STATE OF MAINE
DEPARTMENT OF TRANSPORTATION
16 STATE HOUSE STATION
AUGUSTA, MAINE 04333-0016

January 30, 2026
Subject: Colson Bridge #2168
WIN: 025541.00
Location: **Prospect**
Amendment No. 1

| COLSON BRIDGE NO. 2168 | CROSSING COLSON STREAM | PROSPECT | ESTIMATED QUANTITIES & GENERAL CONSTRUCTION NOTES |

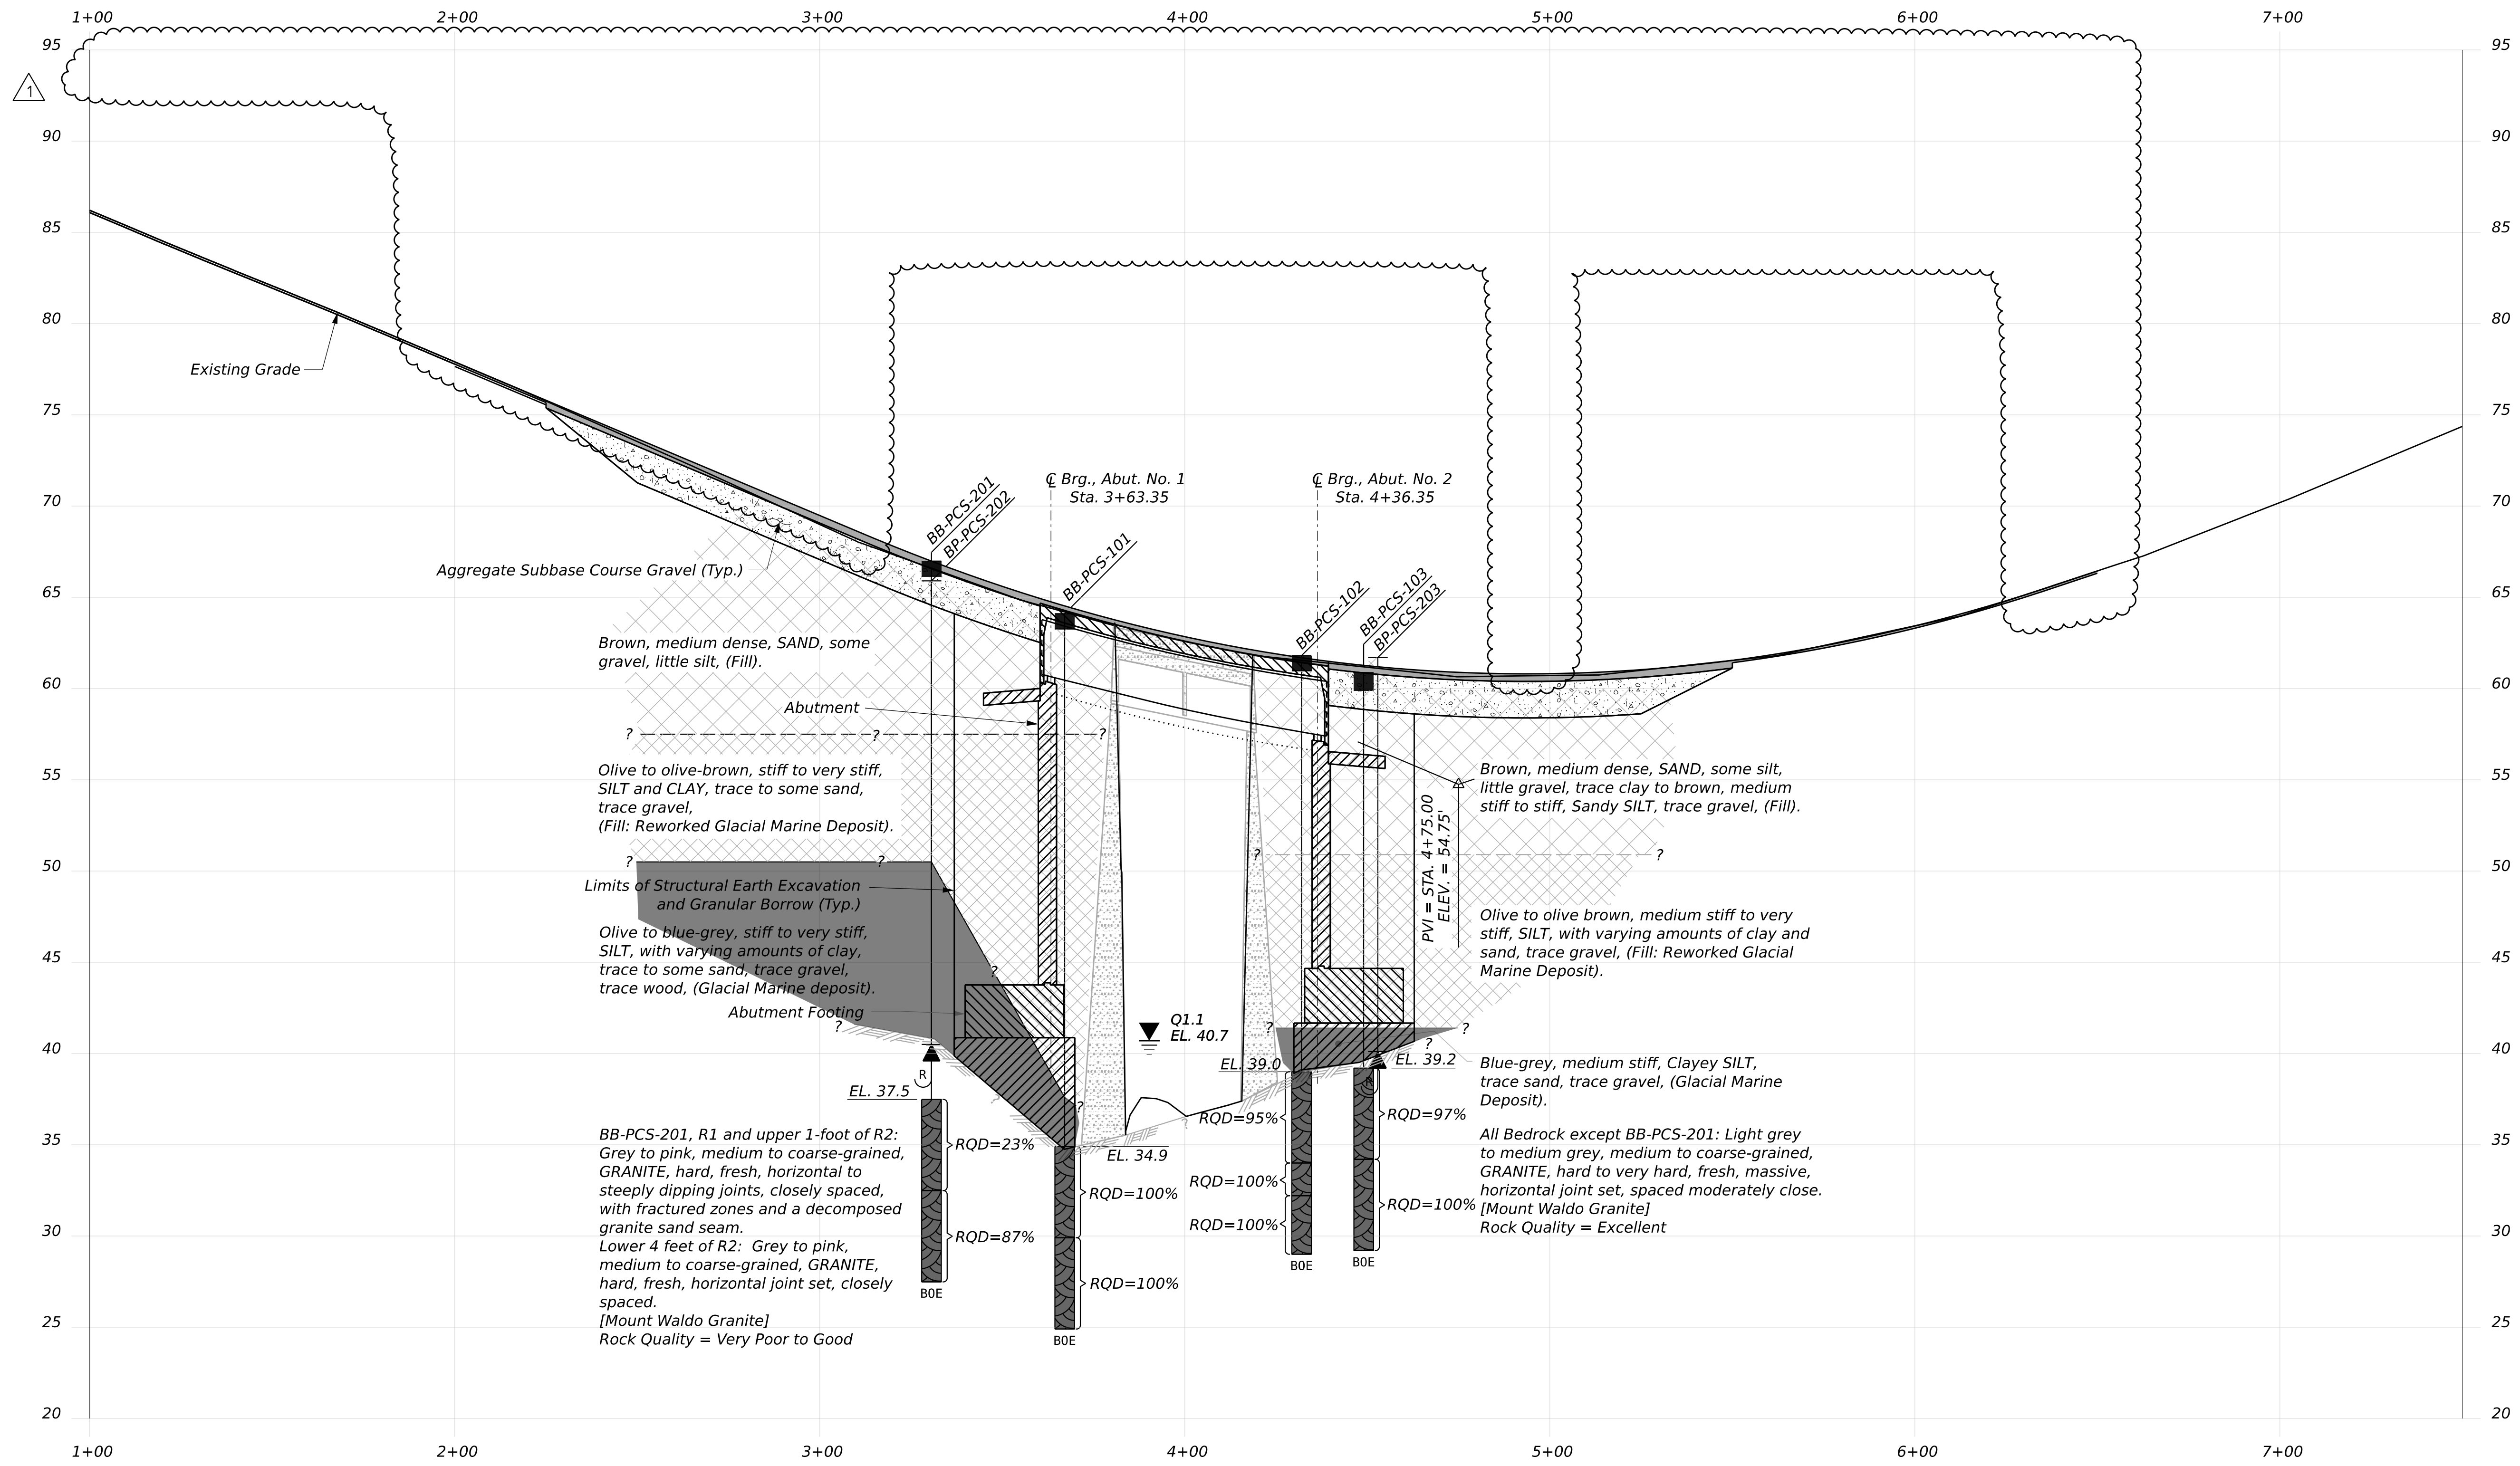
Question: Please reference existing plans labeled Abutment No.1 and Abutment No. 2 dated Feb 1976. Please confirm that only the parapet portion of the wingwall was removed and that the remainder of the abutments are still in place. If so, how will removal of the old wingwalls be paid (Item 202.19 or one of the excavation items)? Has this quantity been considered in the parenthetic quantity if to be paid in item 202.19?

Question: Please verify the underlying quantity for item 202.19 Remove Existing Bridge.

Question: Notes 21 and 22 on sheet 2 are unclear. Please verify areas of common excavation, structural earth, and incidental excavation to 202.19.

Response: There is no guarantee as to how much of the old wingwalls were removed. For estimating purposes, it was assumed that the parapet removals matched those shown in the 1976 existing plans, and the remaining sections of the old abutments are to be paid for under Item 202.19 – Removing Existing Bridge. Please see parenthetic quantity on revised Sheet 2.

Response: There is no guarantee as to how much of the old abutments are remaining. For estimating purposes, it was assumed that the parapet removals matched those shown in the 1976 existing plans, and the remaining sections of the old abutments are to be paid for under Item 202.19 – Removing Existing Bridge. Please see parenthetic quantity on revised Sheet 2.

Response: All material between the existing and proposed abutments not otherwise classified as structural earth excavation shall be considered incidental to Pay item 202.19, Removing Existing Bridge. See revised sheet 2.

- Payment for the removal and disposal of any material that is adjacent to the existing bridge and outside the limits of Structural Earth Excavation of the new bridge shall be considered incidental to Pay Item No. 202.19, Removing Existing Bridge.

COLSON BRIDGE NO. 2168
CROSSING COLSON STREAM
PROSPECT
TYPICAL SECTIONS

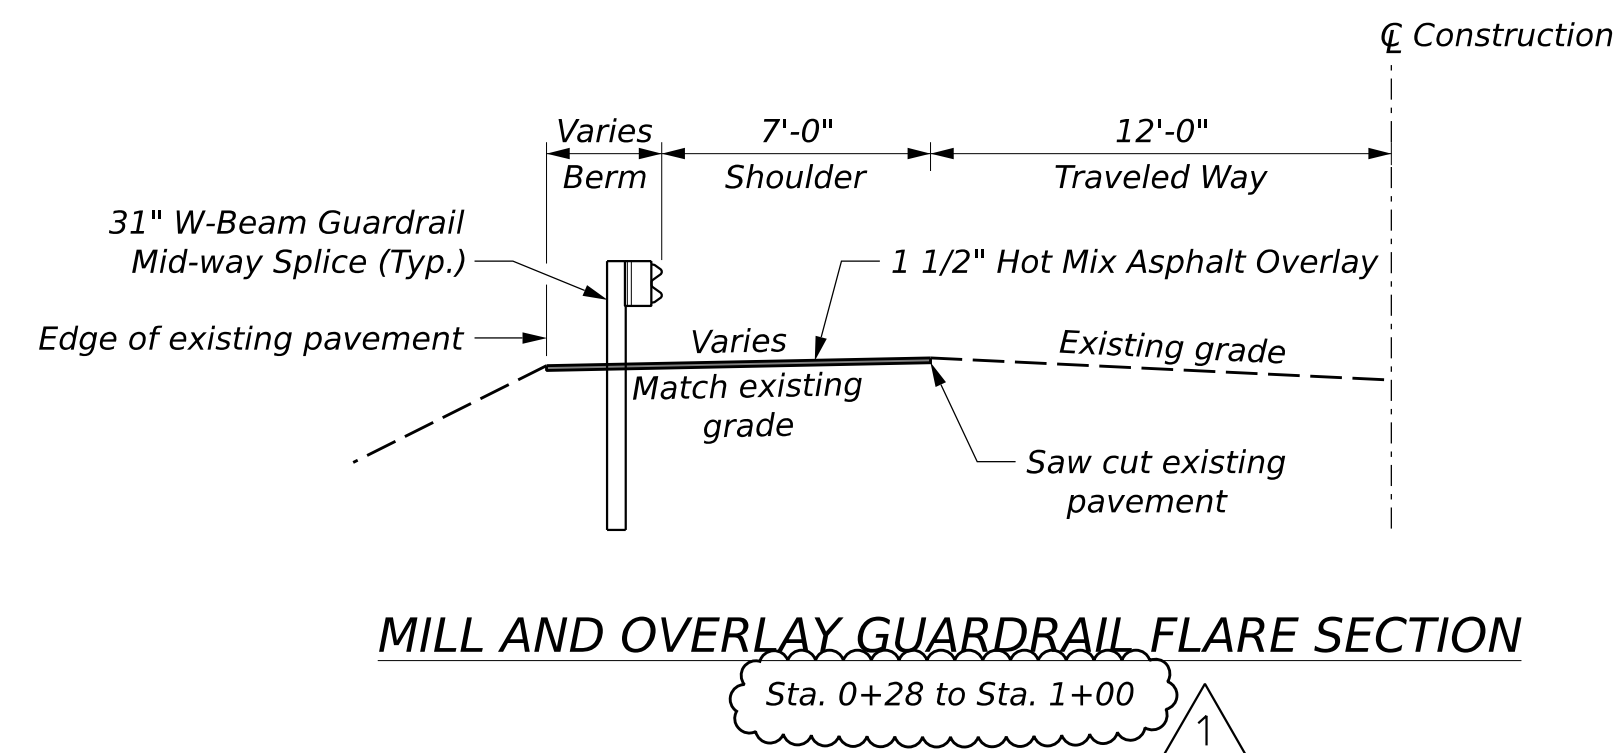
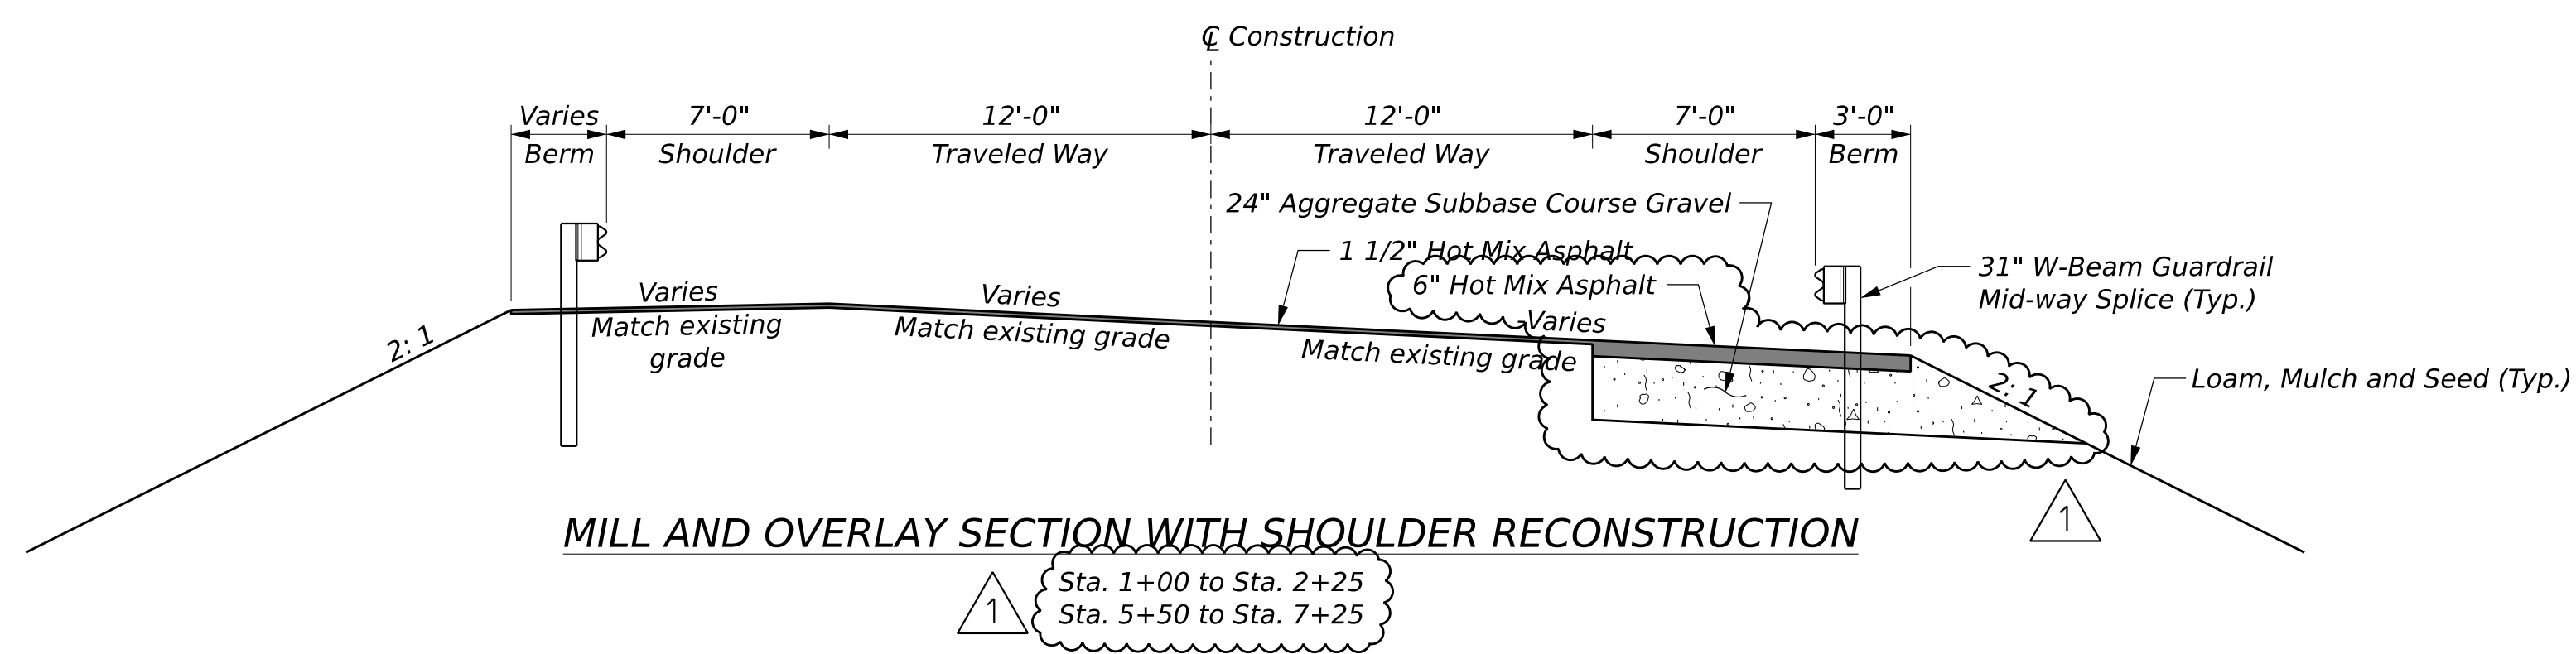
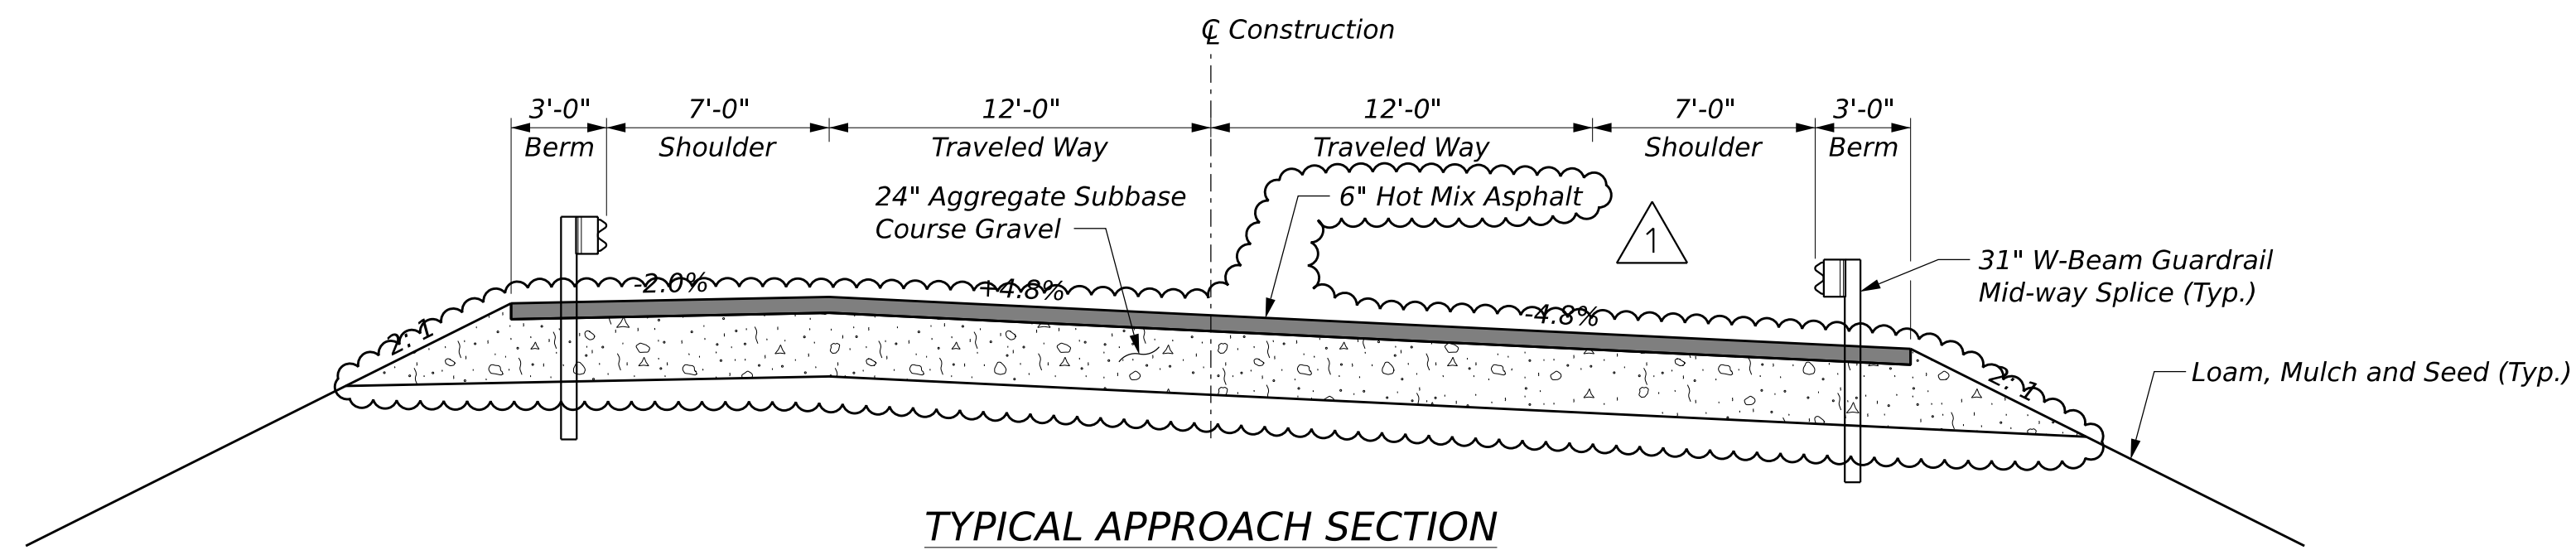
Question: The profile sheet(s), cross sections and typical sections indicate there is 5” of total HMA but the 403SP Specials page state there is 6” of total HMA in the Full Depth Construction areas. Would the department please clarify how much total HMA is being placed in the reconstruction areas?

Question: Similarly to question 1, the shoulder reconstruction areas are also not clear how much total HMA is expected to be placed. Does the department want 3” of total HMA in these areas or 5” or 6” of total HMA (depending upon the department’s answer to question 1).

Response: The total HMA depth in Full Depth Reconstruction Areas, for both travel way and shoulders, shall be 6”.

Response: See Typical Sections on revised Sheet 9 for the depth of pavement required on the shoulders.
